Addendum 1

June 16, 2025

Fort Wayne Airport JEKCC Infrastructure Improvements

Description: Modification Section P – Bid Item Schedule

**SITE PLAN - NORTHWEST
PERIMETER ROAD**

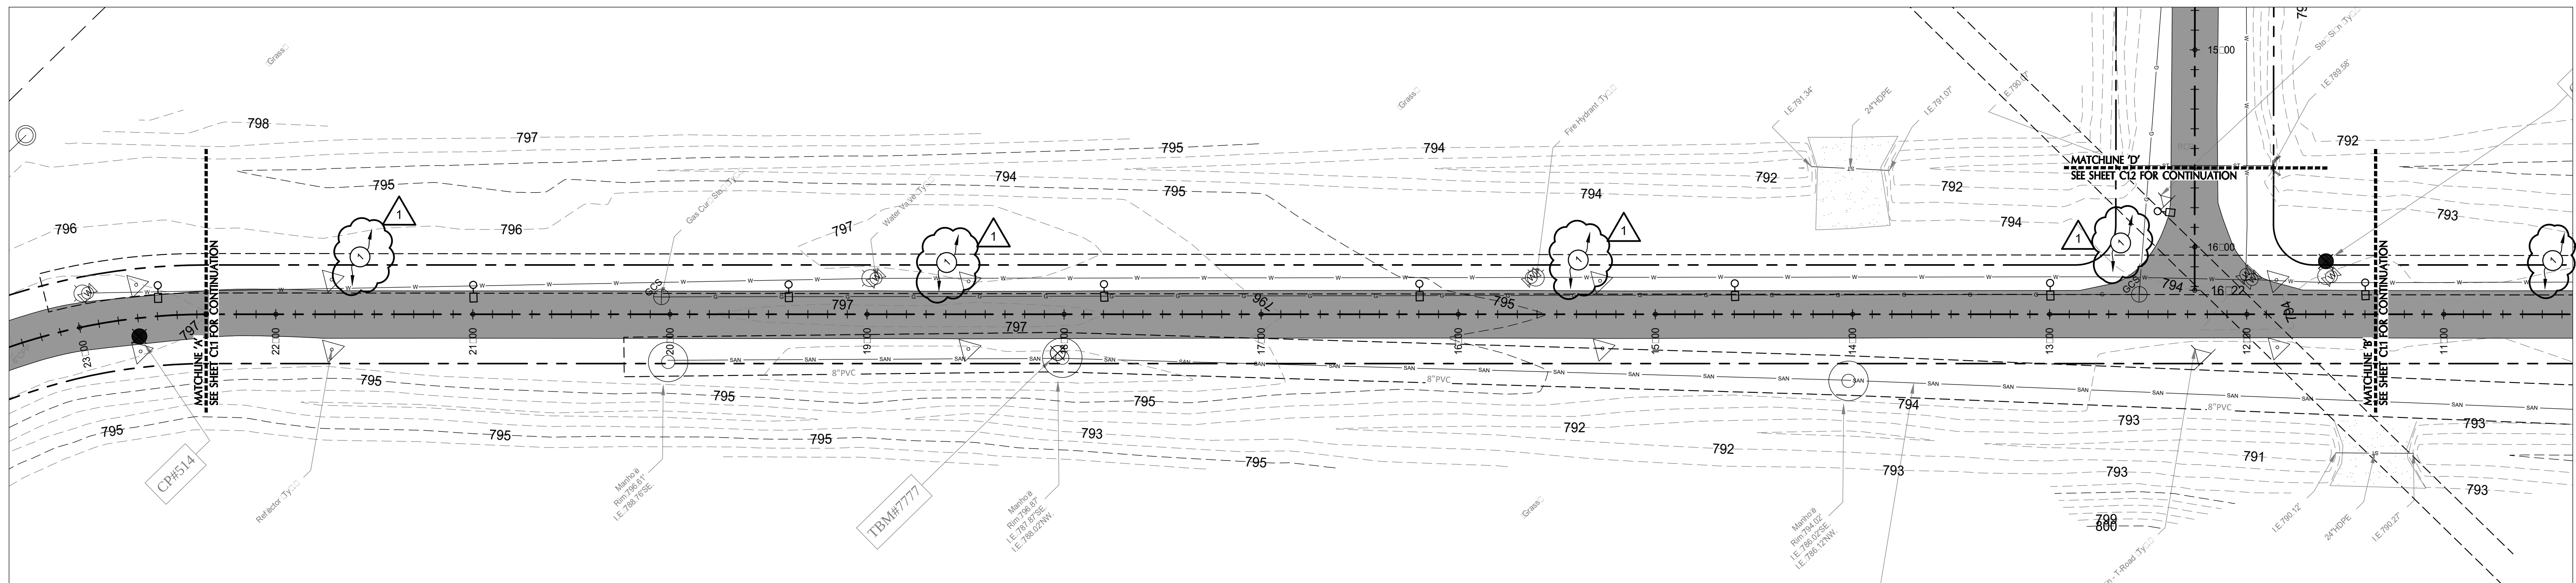
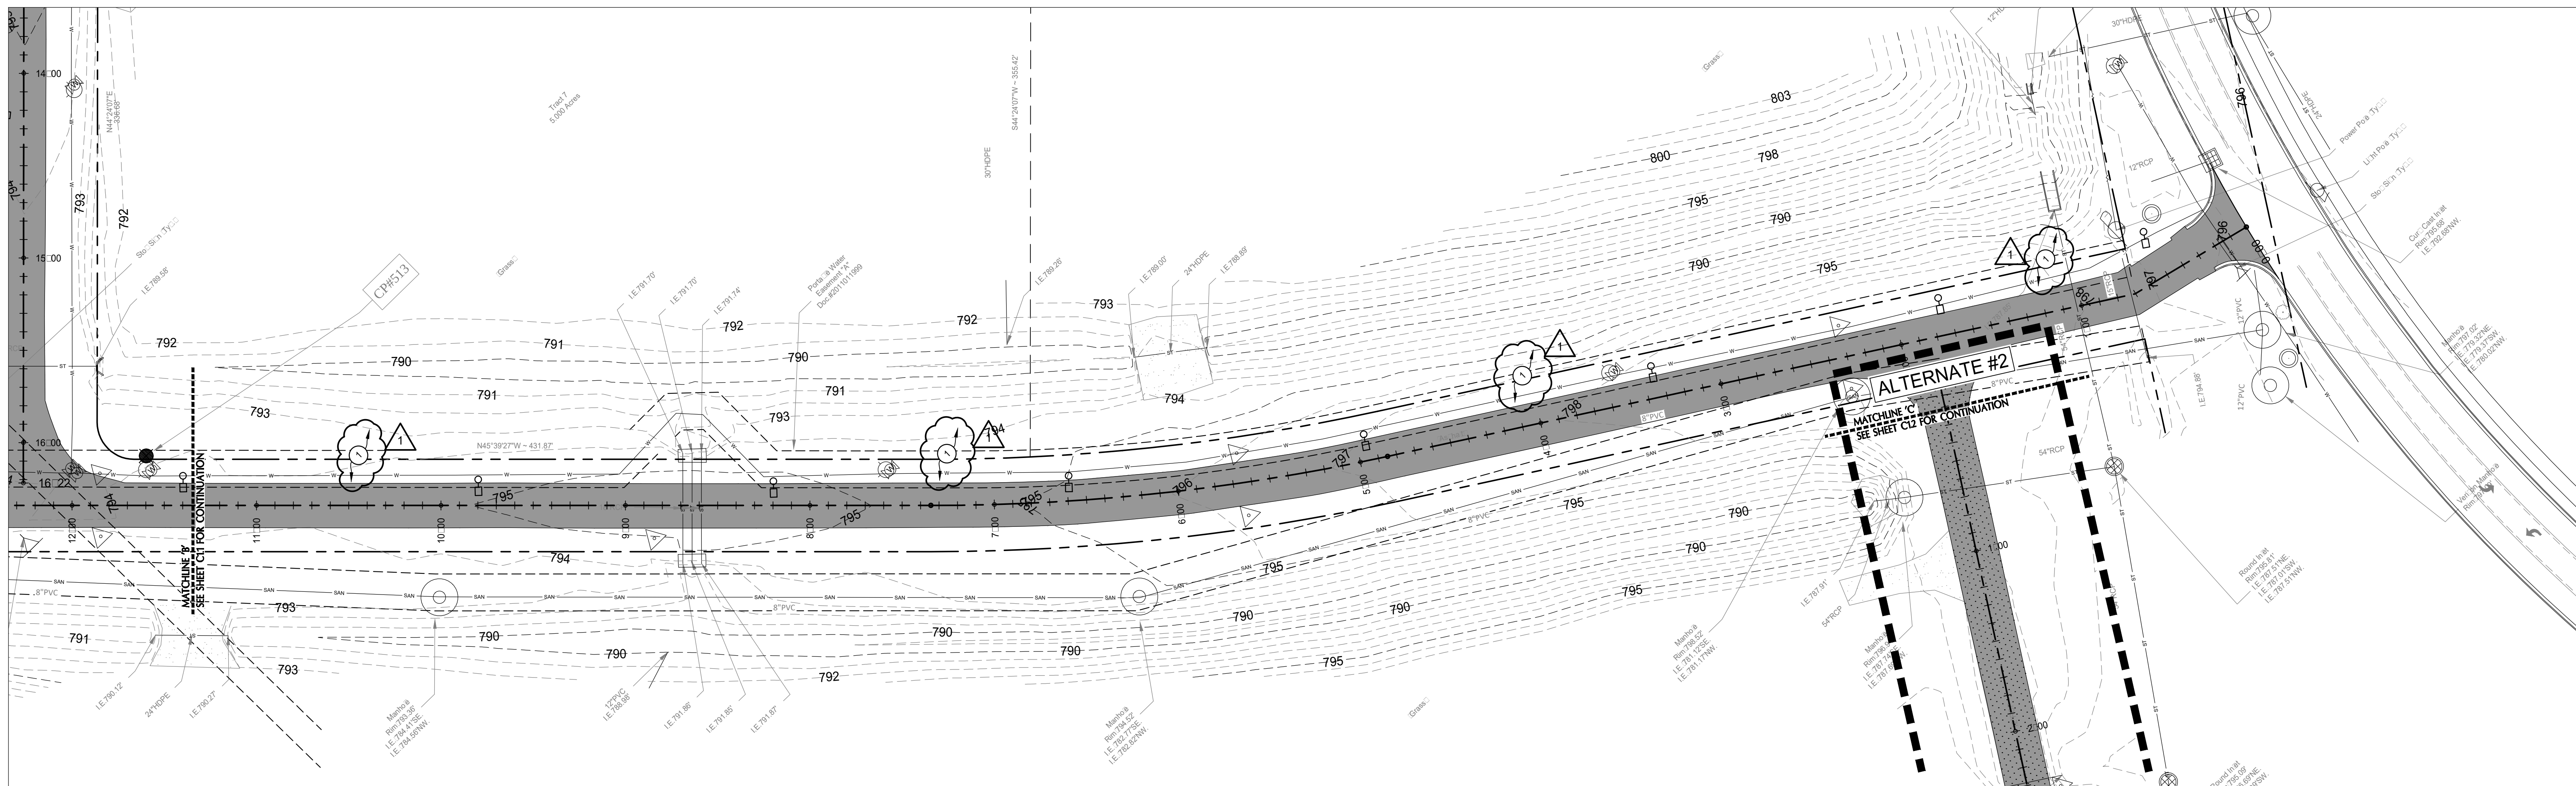
- A. Addition of Layout Note 1 to C1.1 and C1.2 in areas of disturbance.

1 GRASS/LANDSCAPE AREA: ALL DISTURBED AREAS TO RECEIVE PERMANENT SEEDING. SEE SPECIFICATIONS SECTION 029200 "LAWNS & GRASSES".

TYPICAL CROSS SECTION
NOT TO SCALE

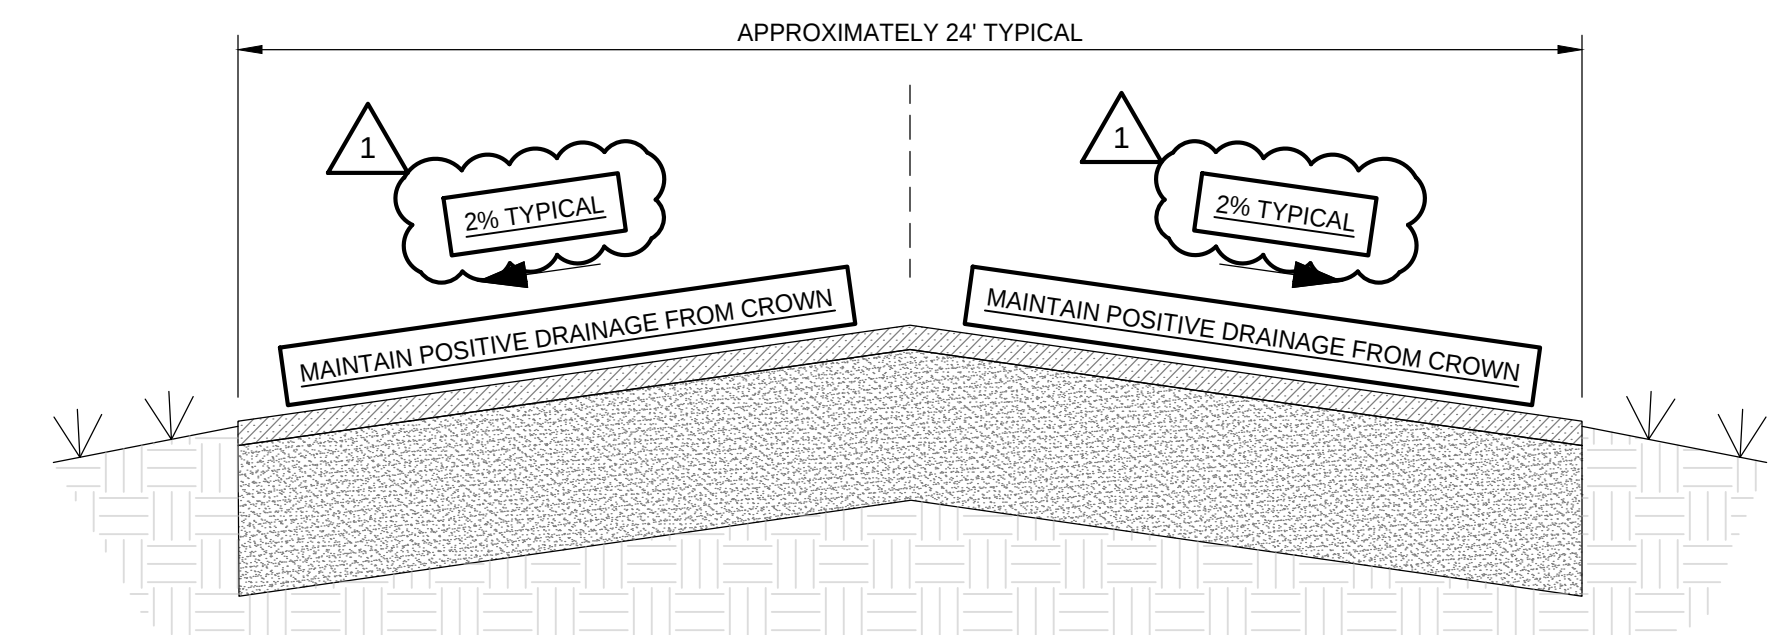
- A. Crown of road clarified to be 2% typical slope in Typical Cross Section on C1.2.

**1**
E1.1
ELECTRICAL SITE PLAN
1\"/>

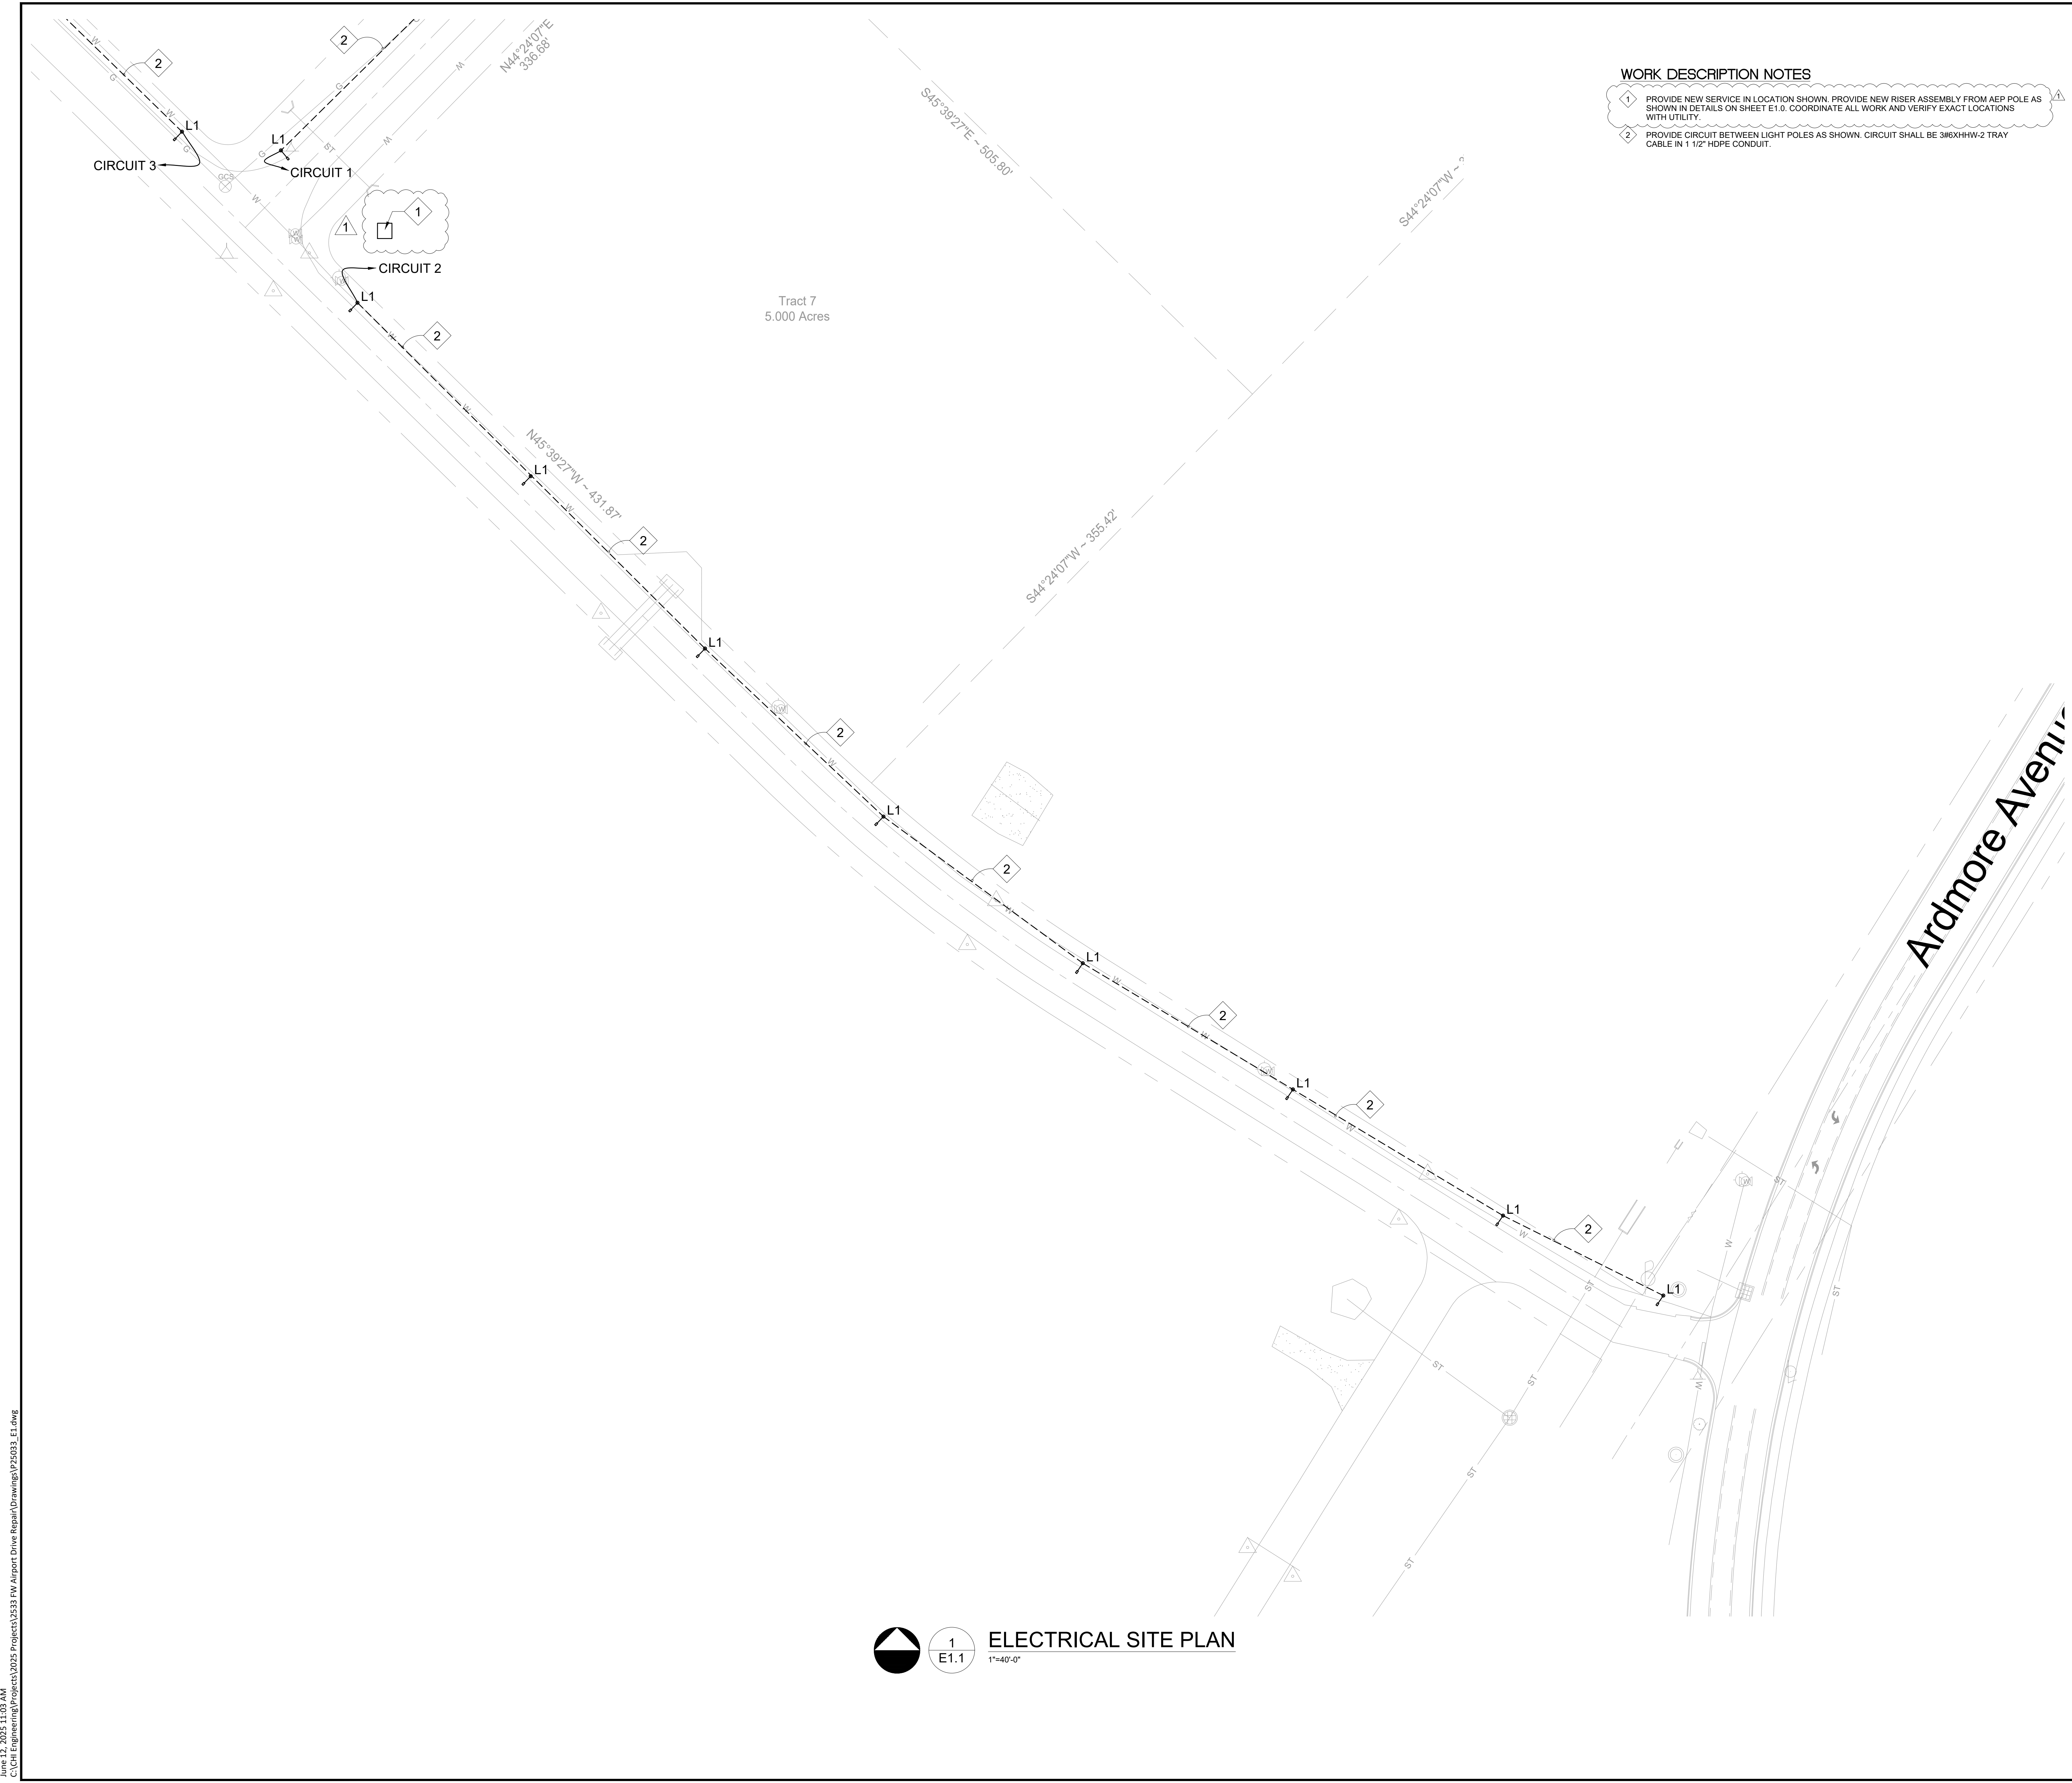
- A. Change of Work Description Note #1 from “New Power Source” to “New Service” and clarification of location from AEP Pole on E1.1, E1.2, and E1.3.
- B. Removal of new power source tag at intersection of Airway Avenue and Ardmore Avenue.

- WORK DESCRIPTION NOTES**
- 1 PROVIDE NEW SERVICE IN LOCATION SHOWN. PROVIDE NEW RISER ASSEMBLY FROM AEP POLE AS SHOWN IN DETAILS ON SHEET E1.0. COORDINATE ALL WORK AND VERIFY EXACT LOCATIONS WITH UTILITY.
 - 2 PROVIDE CIRCUIT BETWEEN LIGHT POLES AS SHOWN. CIRCUIT SHALL BE 3#6XHHW-2 TRAY CABLE IN 1 1/2\"/>
